Mobile Intel[®] Celeron[®] Processor at 466 MHz, 433 MHz, 400 MHz, 366 MHz, 333 MHz, 300 MHz, and 266 MHz Specification Update

Release Date: October 2001

Order Number: 244444-027

Figure 2. Workaround Flowchart: SMBALERT#-Driven System

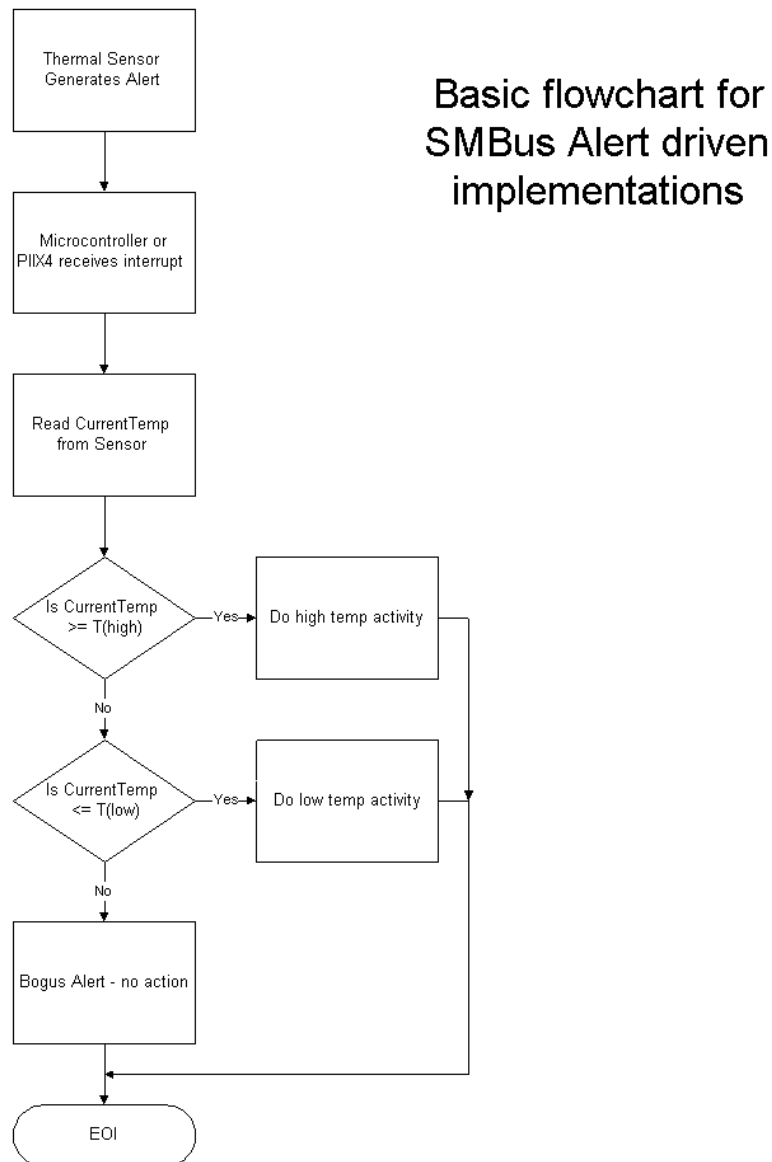
H29. Thermal Sensor May Assert SMBALERT# Incorrectly

Problem: The Intel Celeron Processor Mobile Module has a thermal sensor that monitors the processor core's temperature. Please note that desktop systems could have a similar thermal device. The thermal sensor asserts SMBALERT# if the processor temperature exceeds the temperature limits set in the Alarm Threshold Registers (T_{HIGH} , T_{LOW}). It also sets the corresponding Status Register bits to identify the cause of the interrupt. Figure 1 gives one example of the how the SMBALERT# signal could be used in a system.

Workaround: Three different (mutually exclusive) workarounds are possible:

1. Before servicing an interrupt from the thermal sensor, read and compare the processor thermal reading with the threshold limits (T_{HIGH} or T_{LOW}). Figures 2 and 3 provide basic flowcharts for the implementation of this workaround in an interrupt driven system.
2. If the firmware implemented polls the Status Register only, then before taking any action, re-read the temperature register and do a comparison with the alarm threshold limits (T_{HIGH} or T_{LOW}) to determine if the value is actually still within the temperature window.
3. Use a temperature polling scheme to monitor the processor temperature.
